ECE/TRANS/WP.29/GRE/2006/51
21 July 2006

World Forum for Harmonization of Vehicle Regulations (WP.29)

PROPOSAL FOR DRAFT 03 SERIES OF AMENDMENTS TO REGULATION No. 10

(Electromagnetic compatibility)

Appendix 2

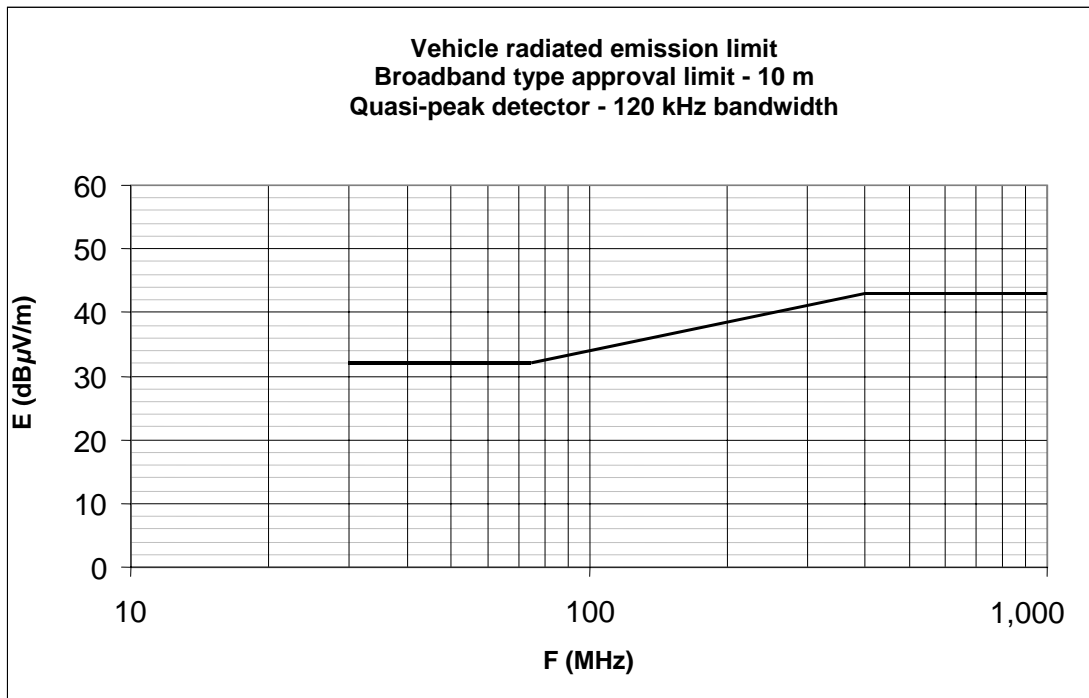
Appendices 1 to 6, amend to read:

Limit E (dBμV/m) at frequency F (MHz)		
30 - 75 MHz	75 - 400 MHz	400 - 1,000 MHz
E = 32	E = 32 + 15.13 log (F/75)	E = 43

Appendix 3

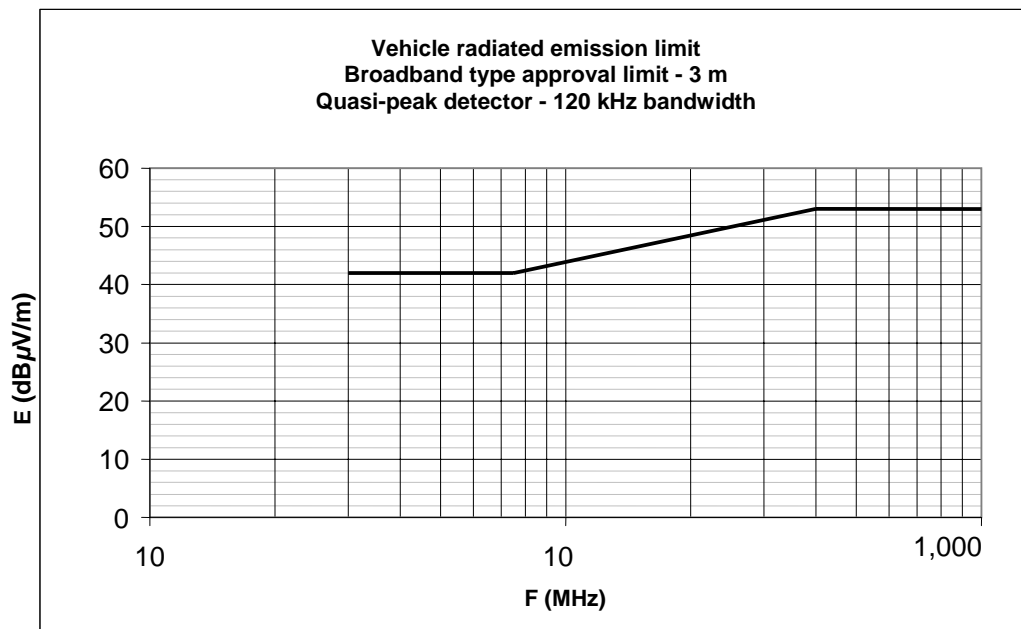
Limit E (dBμV/m) at frequency F (MHz)		
30 - 75 MHz	75 - 400 MHz	400 - 1,000 MHz
E = 42	E = 42 + 15.13 log (F/75)	E = 53

Appendix 4

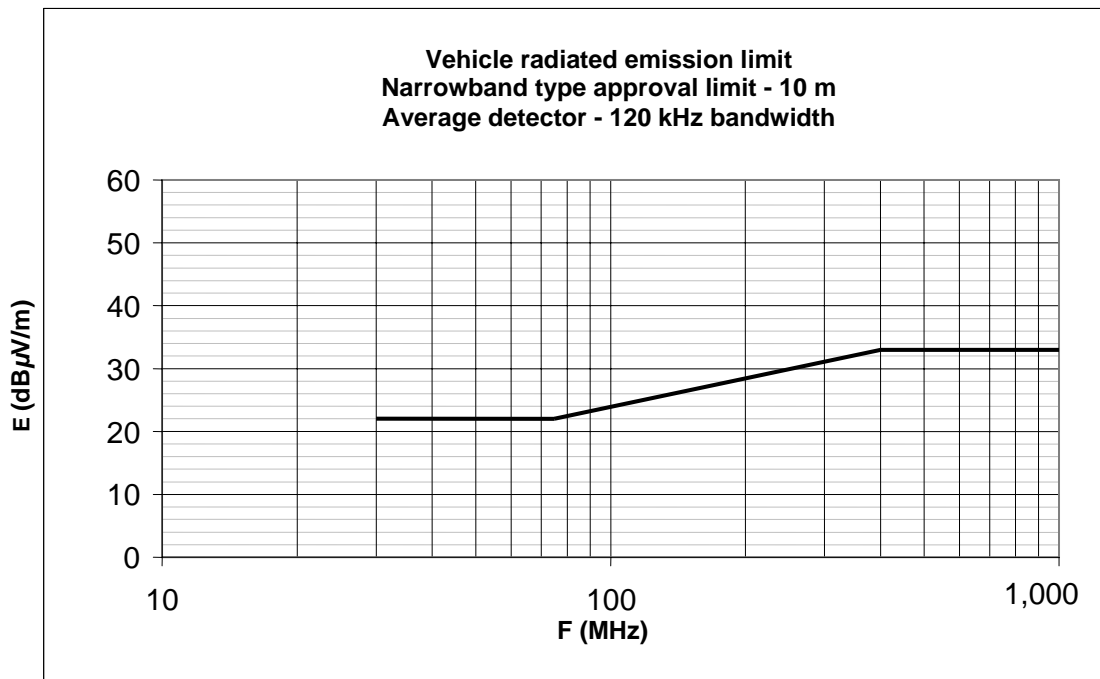
Limit E (dBμV/m) at frequency F (MHz)		
30 - 75 MHz	75 - 400 MHz	400 - 1,000 MHz
E = 22	E = 22 + 15.13 log (F/75)	E = 33

Appendix 5

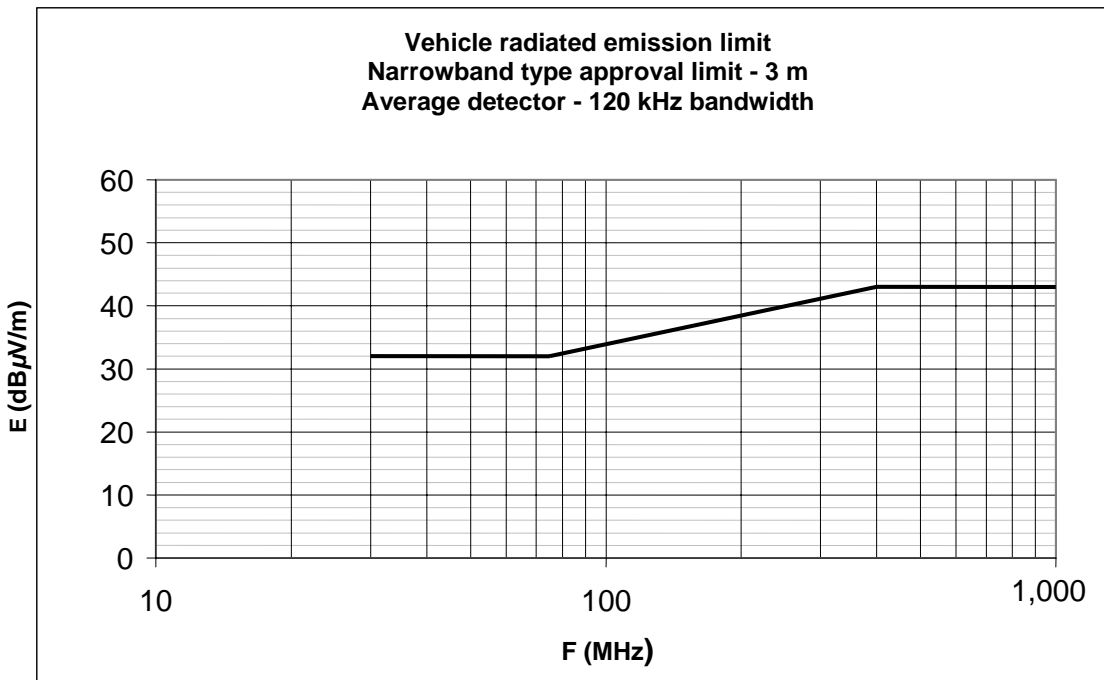
Limit E (dBμV/m) at frequency F (MHz)		
30 - 75 MHz	75 - 400 MHz	400 - 1,000 MHz
E = 32	E = 32 + 15.13 log (F/75)	E = 43

Appendix 6

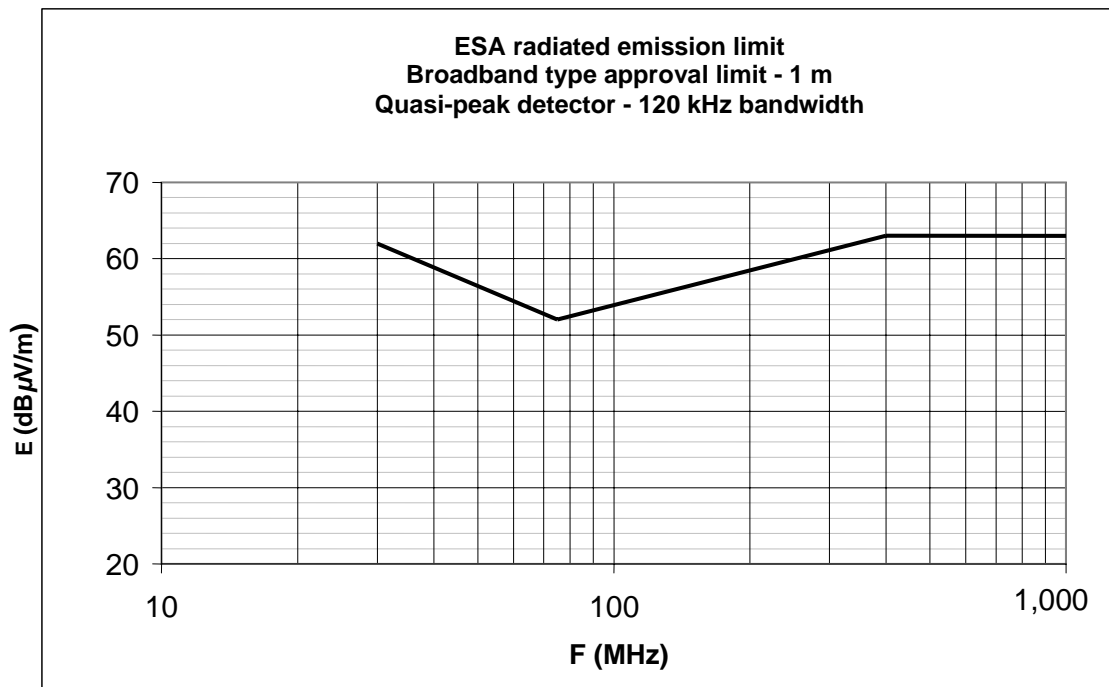
Limit E (dBμV/m) at frequency F (MHz)		
30 - 75 MHz	75 - 400 MHz	400 - 1,000 MHz
$E = 62 - 25.13 \log (F/30)$	$E = 52 + 15.13 \log (F/75)$	$E = 63$

"Appendix 7

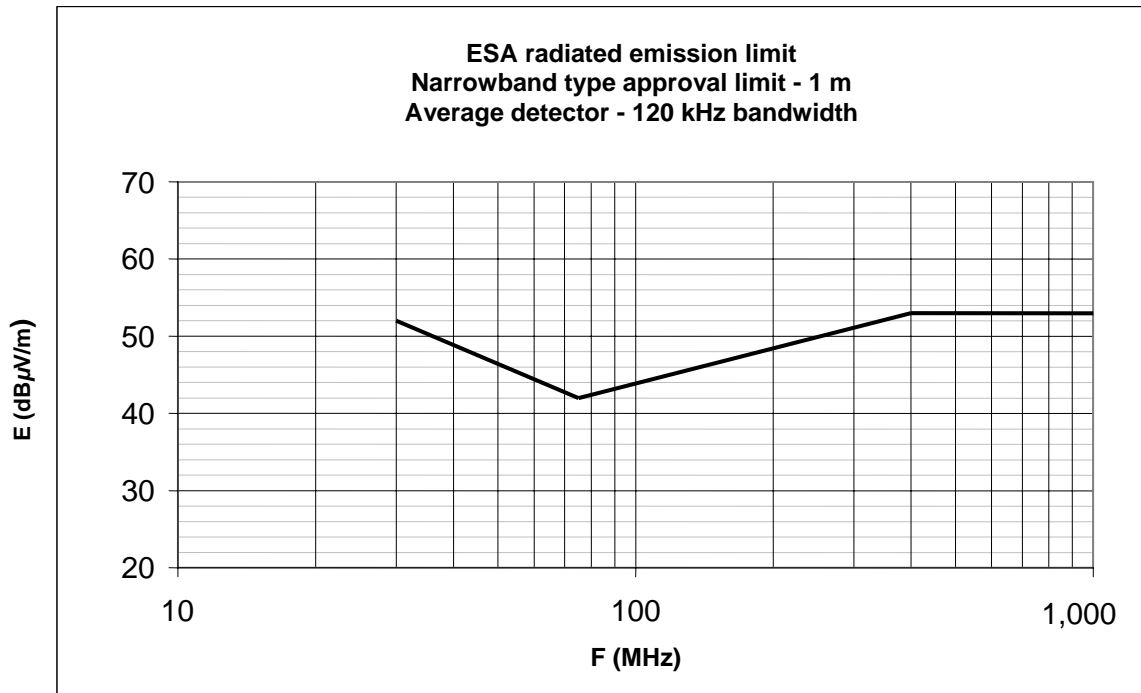
Insert a new Appendix 7, to read:

Limit E (dBμV/m) at frequency F (MHz)		
30 - 75 MHz	75 - 400 MHz	400 - 1,000 MHz
$E = 52 - 25.13 \log (F/30)$	$E = 42 + 15.13 \log (F/75)$	$E = 53$

Figure 1

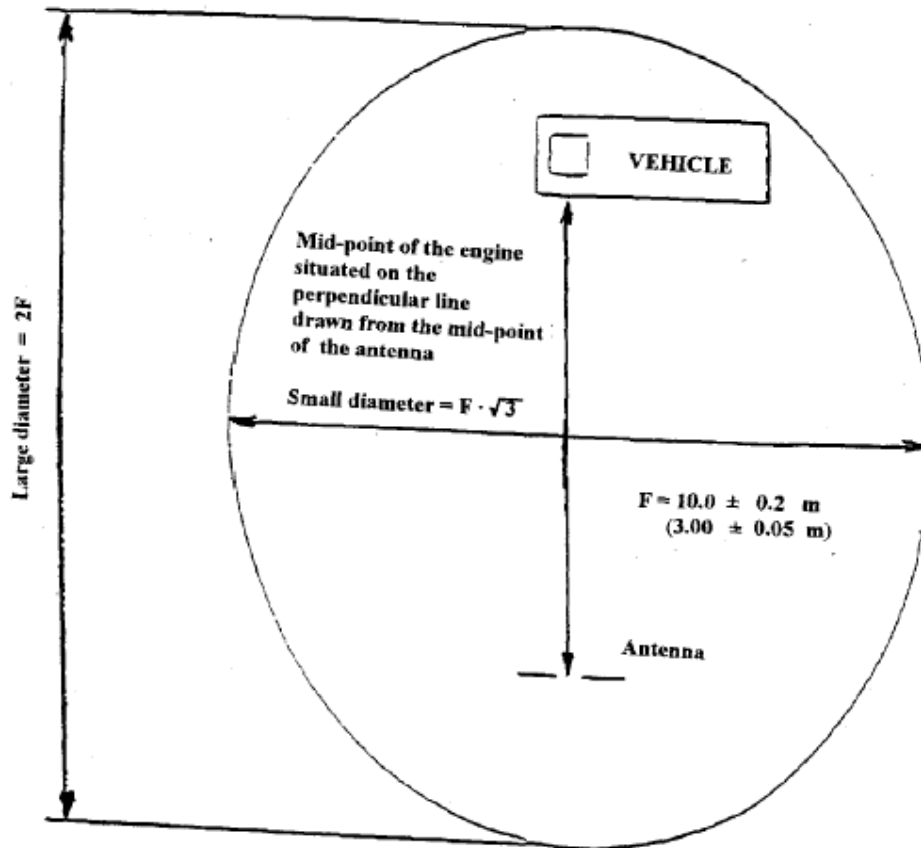
3.1 **As an alternative to the requirements of CISPR 12 (amendment 1, fifth edition 2005) for vehicles of category L the test surface may be any location that fulfils the conditions shown in the figure 1 in the appendix to this annex. In this case the measuring equipment must lie outside the part shown in the figures 1 and 2 of Appendix 1 to this annex.**

Clear horizontal surface free of electromagnetic reflection
delimitation of the surface defined by an **ellipse**
